# GROTTO ENGINEERING ASSOCIATES, LLC

April 26, 2024

Subject: Completeness Review No. 3  
Home & Land Development Corp.  
14 & 32 North Peak Street  
Block 35, Lots 8 & 9  
Borough of Highlands, Monmouth County, New Jersey  
Our File No.: PR-0290

1. HLPB2022-10 - COMPLETENESS REVIEW #3 – (February 20, 2024) – Carmela Roberts, P.E., C.M.E., C.P.W.M., Land Use Board Engineer

PROFESSIONAL ENGINEER  
NEW JERSEY LICENSE NO. GE51556

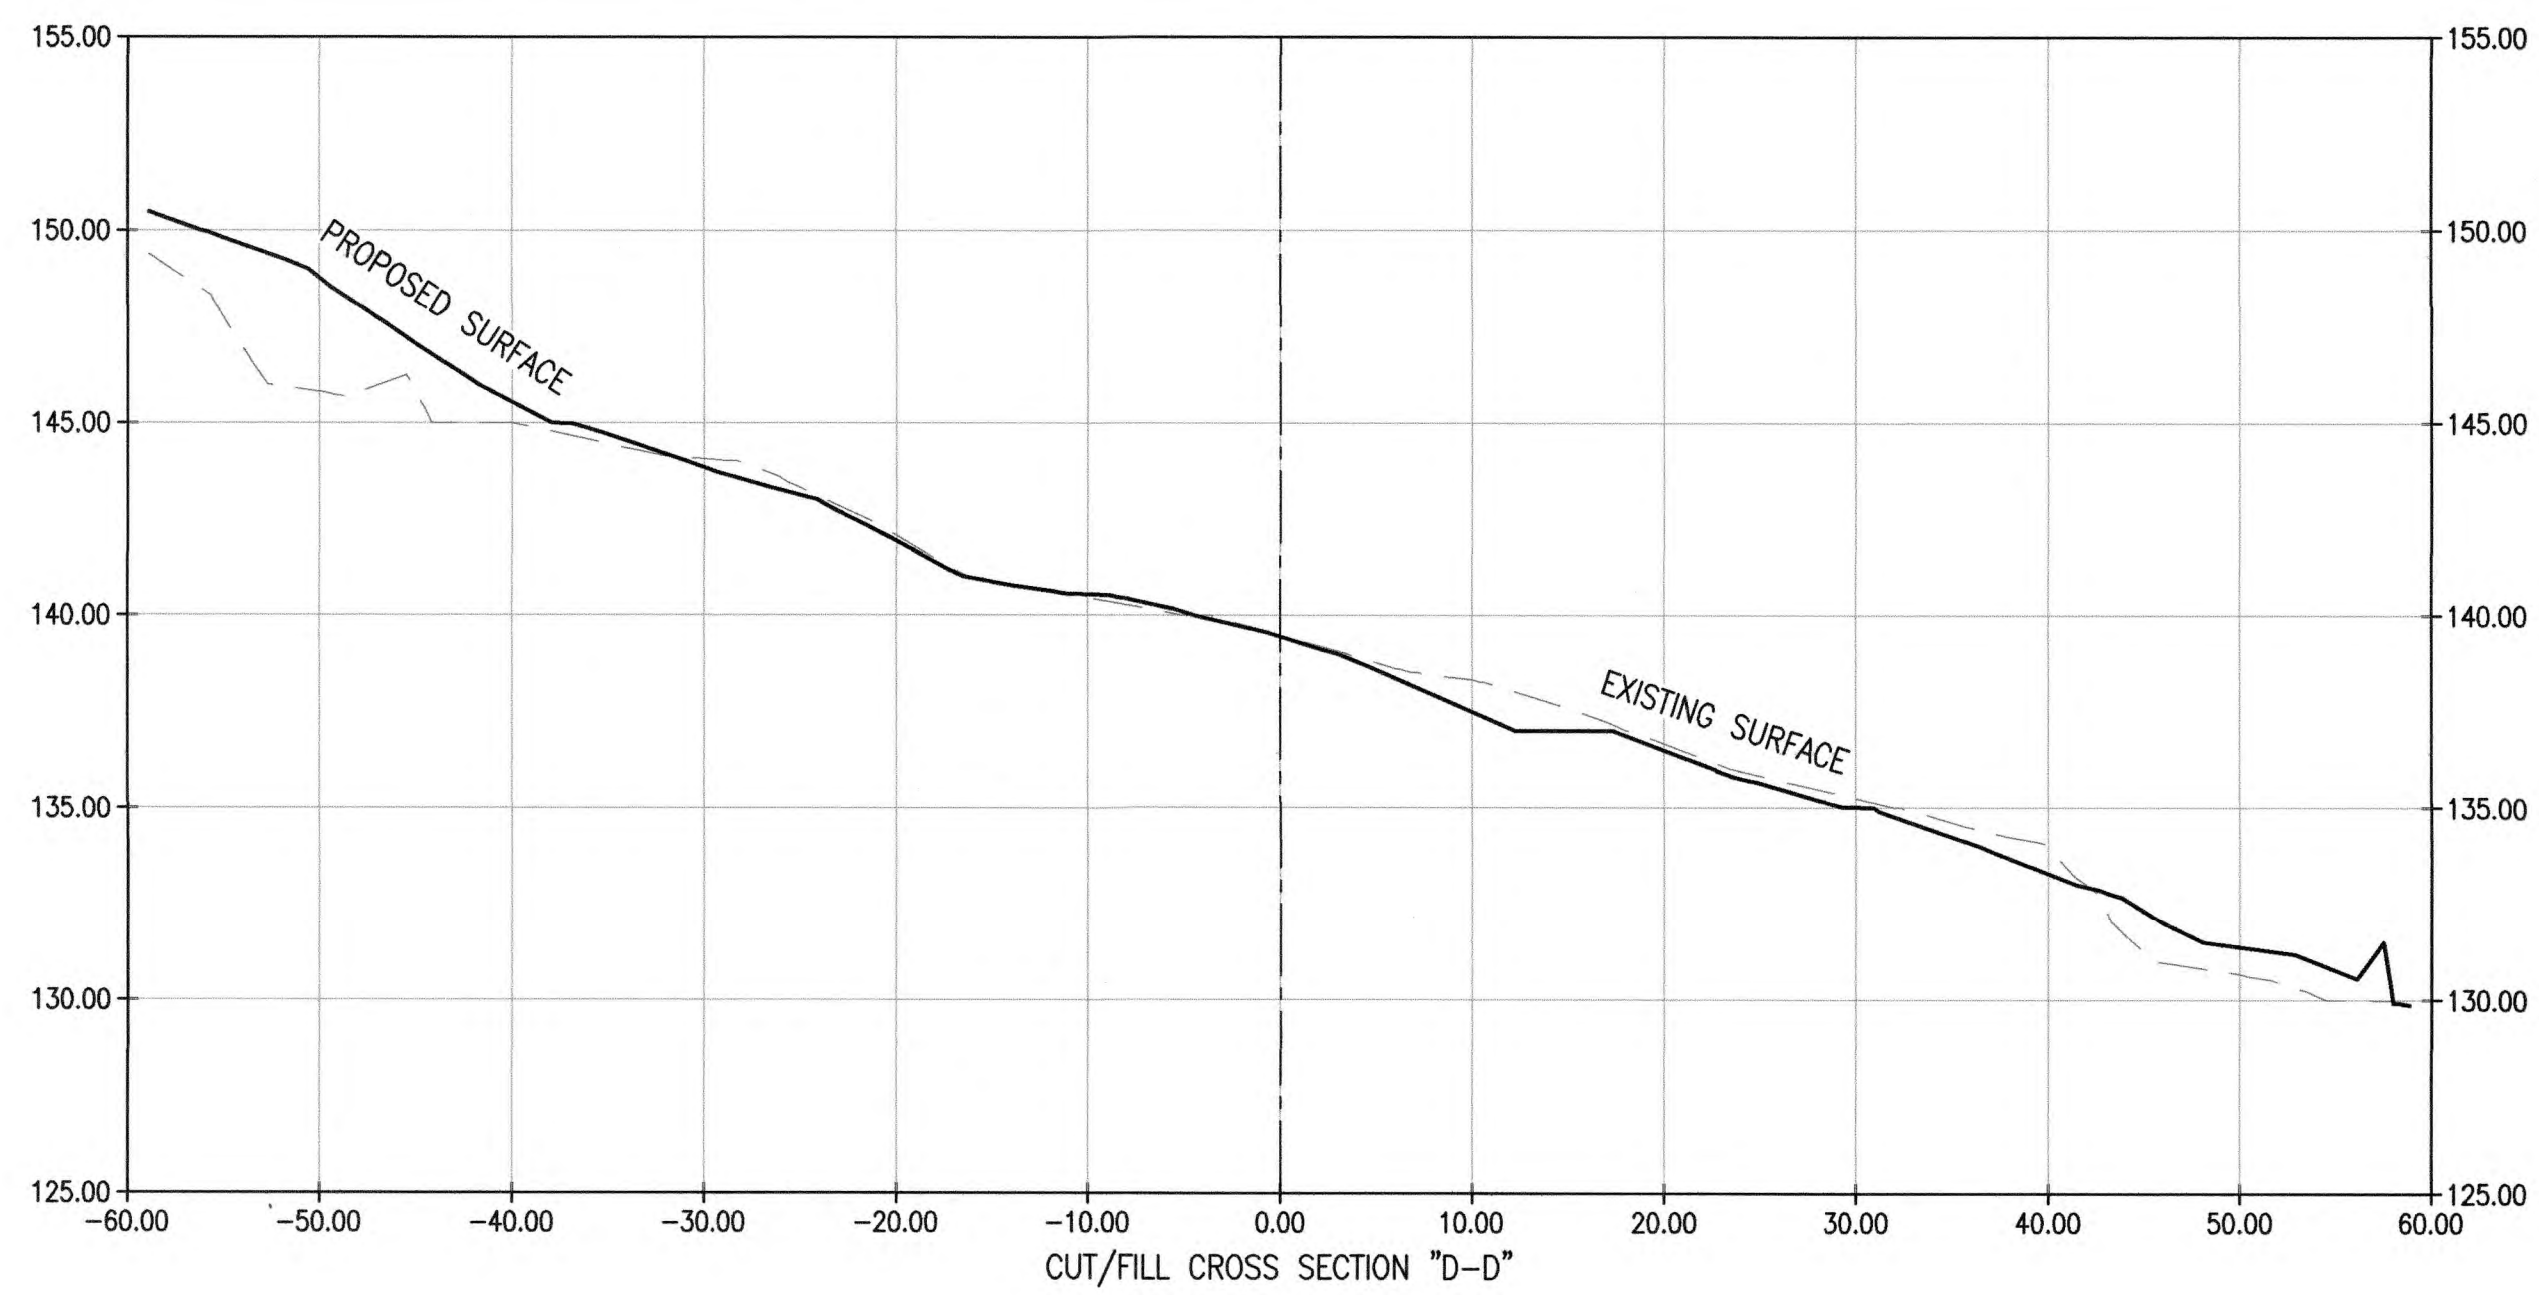
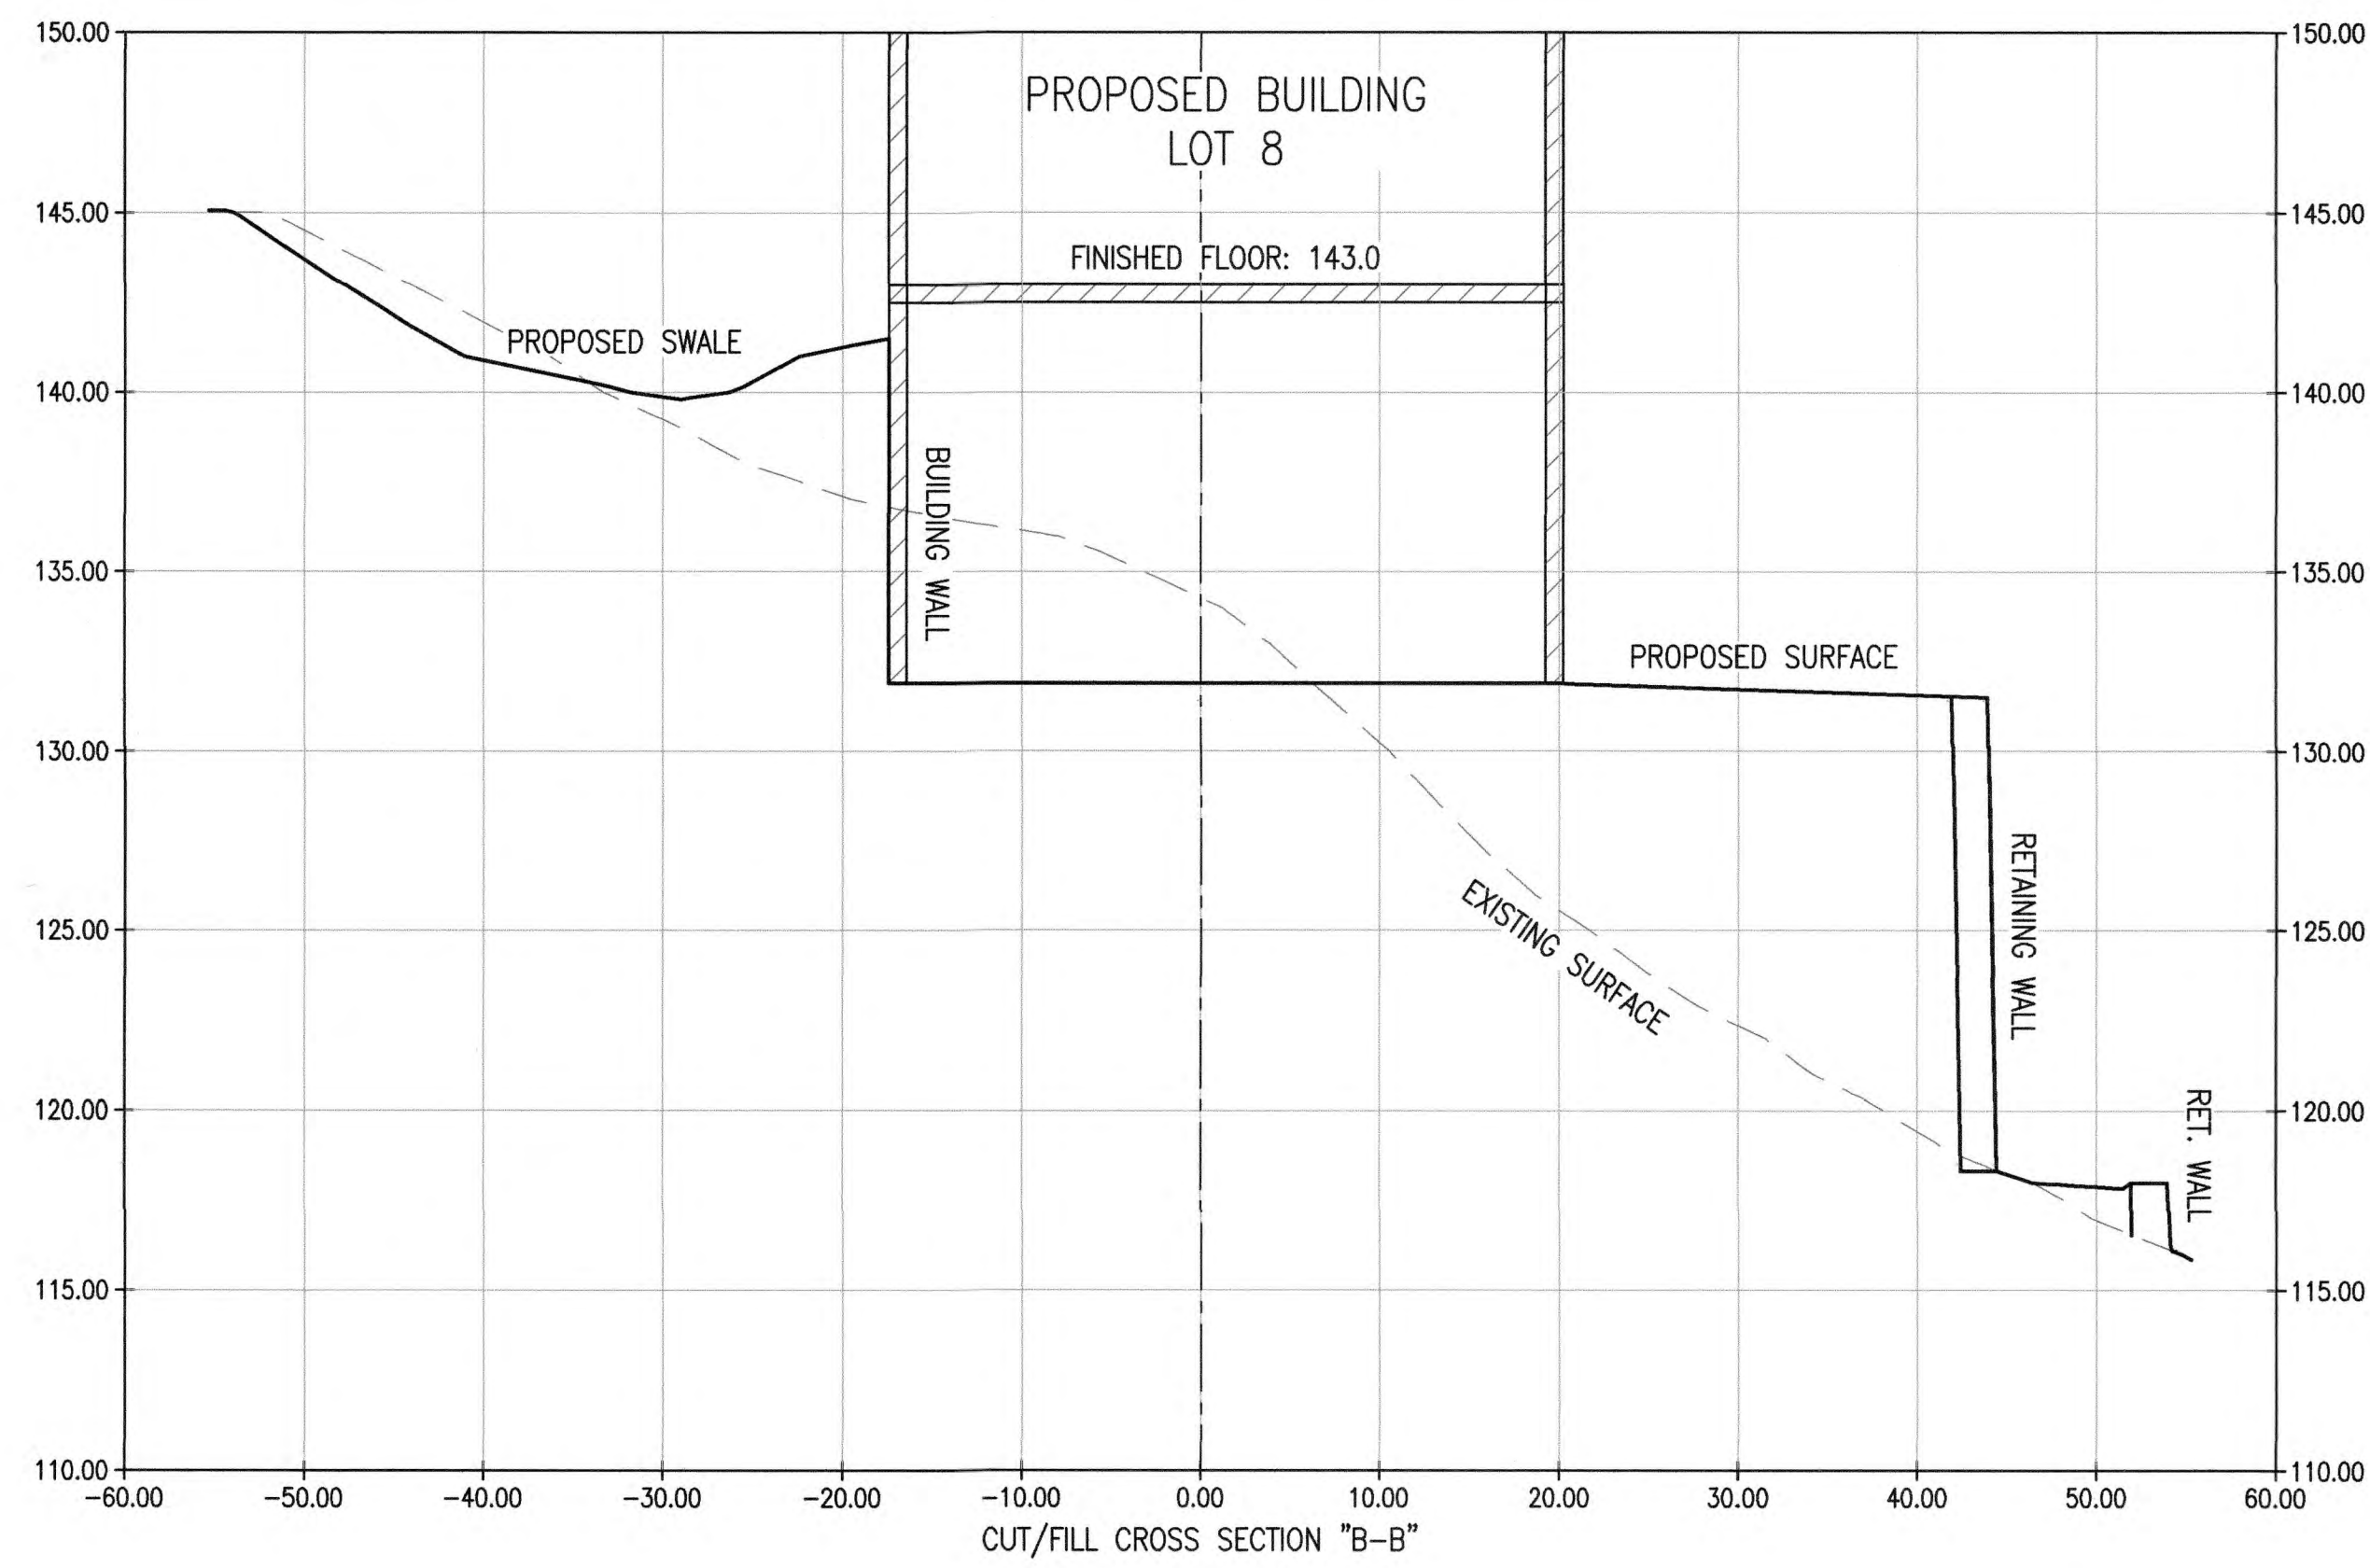
- l. Calculation of amount of site grading, to include a cut-and-fill balance sheet, including cross sections, and indicating, where applicable, the volume of and source of off-site fill.

**Cut-and-fill cross sections and calculations are provided on sheet 6 of the accompanying plans. Source of fill is to be determined.**

**SOIL EROSION AND SEDIMENT CONTROL PLAN**

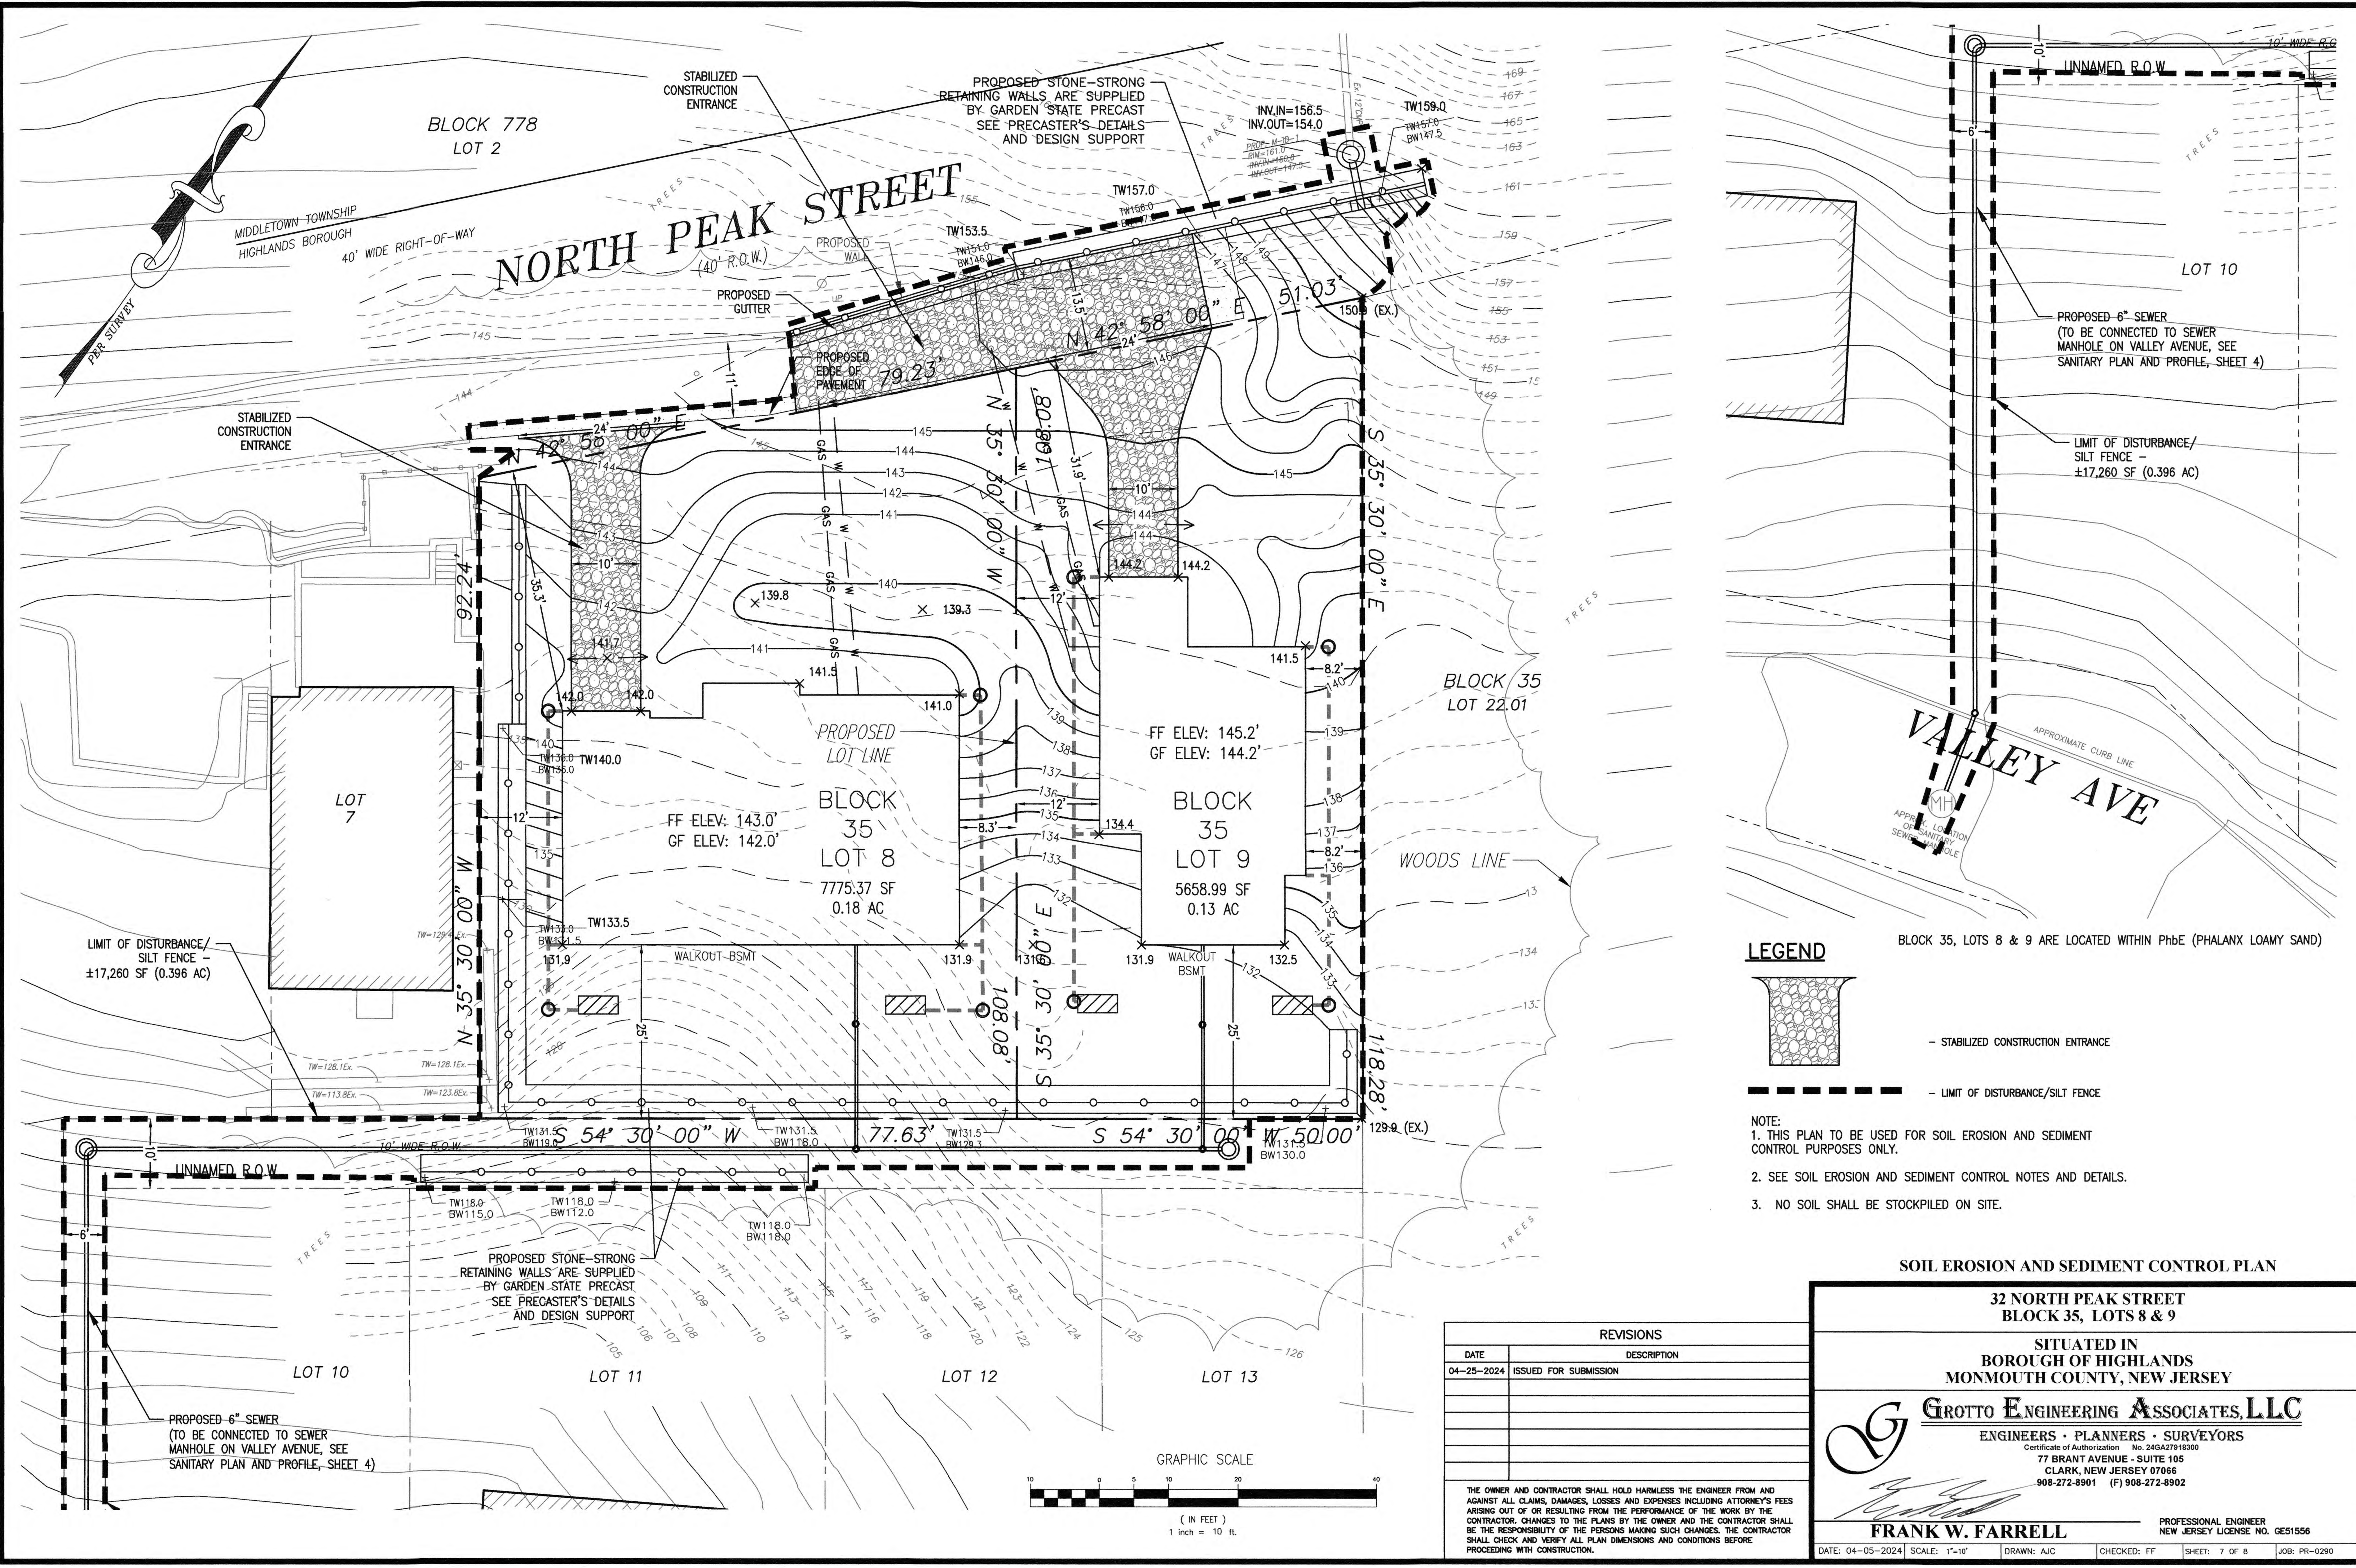
- b. It appears that the applicant has previously demolished structures on both lots and performed clearing and some grading. The limit of disturbance already performed should be shown on the plans.

**An existing one-and-a-half story dwelling, deck, shed, retaining walls, various patios, walkways, and other concrete surfaces were demolished. The limit of disturbance was no greater than is being proposed and shown on the Soil Erosion and Sediment Control Plan (sheet 7 of 8).**
